Access Compliance Report

Public Rights-of-Way

Intersection ID: 11775	Main Street: E_18TH_ST	Cross Street: SEIGLE_AV	Location: N
ADA ID: FB8D1AAF7C54	Ramp Type: BlendTrans1	Initial Pass/Fail: Fail	Overall Compliance: No
			Severity Score: 21.25

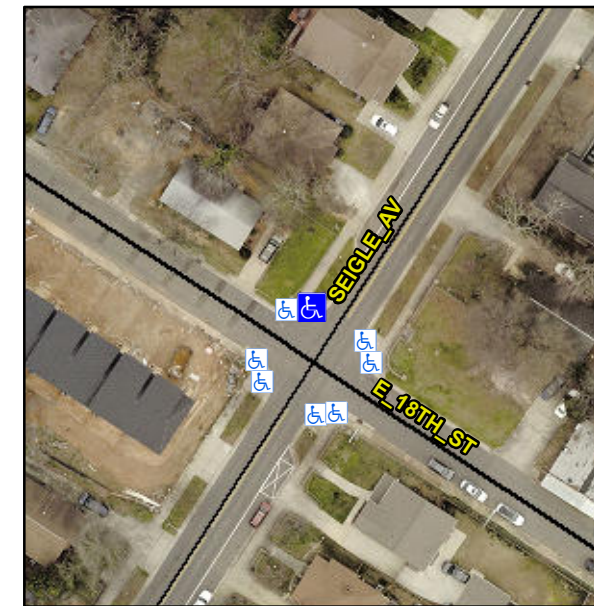
R304.5.1, R304.5.3

Compliance	Description	Data	Compliance	Description	Data
N/A	Ramp Length (in)	65.0	Yes	BlendTrans Slope (%)	0.5
No	Ramp Width (in)	47.5	No	BlendTrans XSlope (%)	6.5
N/A	Flare Type LT	N/A	N/A	Flare Type RT	N/A
N/A	Flare Slope LT (%)	N/A	N/A	Flare Slope RT (%)	N/A
N/A	Flare Traversable LT?	N/A	N/A	Flare Traversable RT?	N/A
N/A	Landing Length (in)	N/A	N/A	DWS Provided?	N/A
N/A	Landing Width (in)	N/A	N/A	DWS Contrast?	N/A
N/A	Landing Slope (%)	N/A	N/A	DWS Length (in)	N/A
N/A	Landing X Slope (%)	N/A	N/A	DWS Full Width?	N/A
N/A	Landing Curb? (Y/N)	N/A	N/A	DWS Offset (in)	N/A
N/A	Shared Landing?	N/A			
N/A	Gutter Ponding?	N/A	N/A	Gutter Slope (%)	N/A
N/A	Gutter Lip Ht (in)	N/A	N/A	Gutter X Slope (%)	N/A
N/A	Painted X Walk1?	No	N/A	Painted X Walk2?	N/A
	X Walk 1 Direction	To SE		X Walk 2 Direction	N/A
	X Walk 1 Width (in)	N/A		X Walk 2 Width (in)	N/A
	X Walk 1 Slope (%)	1.8		X Walk 2 Slope (%)	N/A
	X Walk 1 X Slope (%)	0.2		X Walk 2 X Slope (%)	N/A

Remove & Replace Curb Ramp With Two New Directional Ramps or Equivalent.
